SERVICE BULLETIN CHANGE NOTICE

S.B. No. A320-21-1027

TITLE: AIR CONDITIONING - FLOW CONTROL AND INDICATING - IMPROVE THE
VENTING OF THE PRESSURE PORT

SERVICE BULLETIN NO: A320-21-1027
CHANGE NOTICE NO: 1A

Installation of the Tube Assembly for the Pressure Port
Figure 1

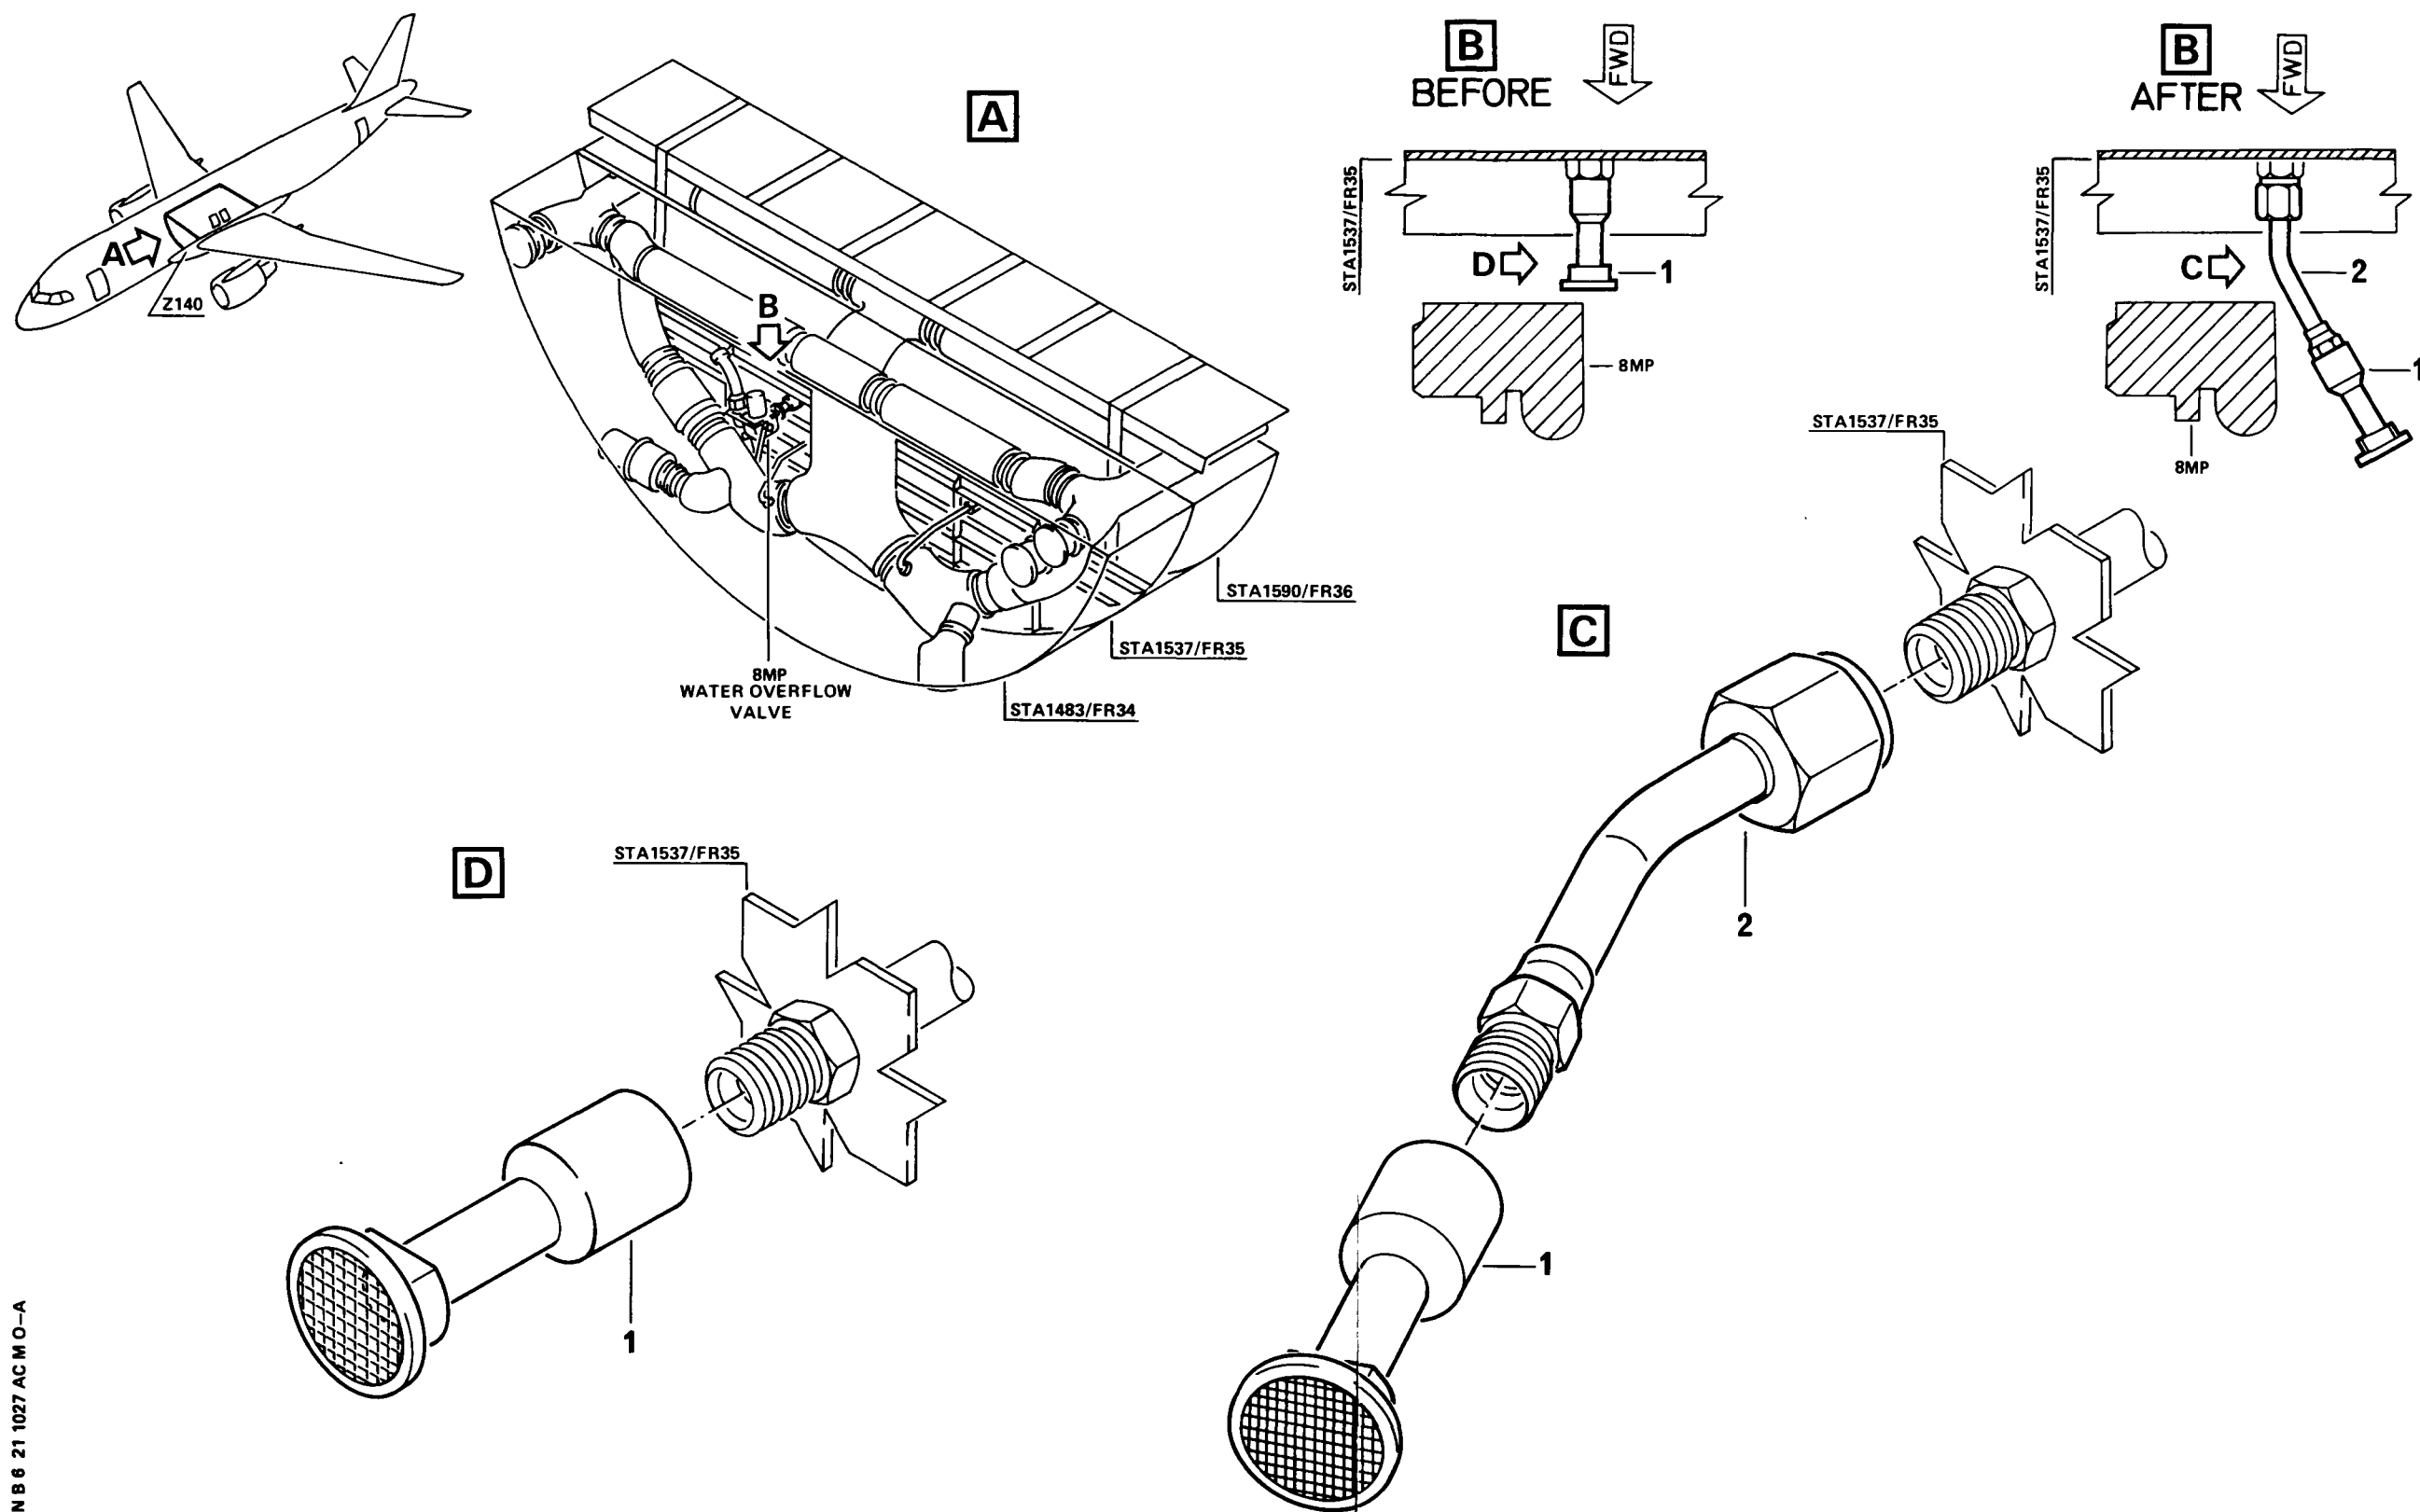
On page 5/6, Para. 2.B.(1)(b), and on page 9, Para. 3.A., change the P/N, item 2, as follows:

From D2127413500000

To D2127413500200

- (a) Remove and retain the pressure port D2127412800000, item 1.
- (b) Install the new tube assembly D2127413500000, item 2, as shown.
- (c) Install the retained pressure port, item 1, on the tube assembly, item 2, as shown.
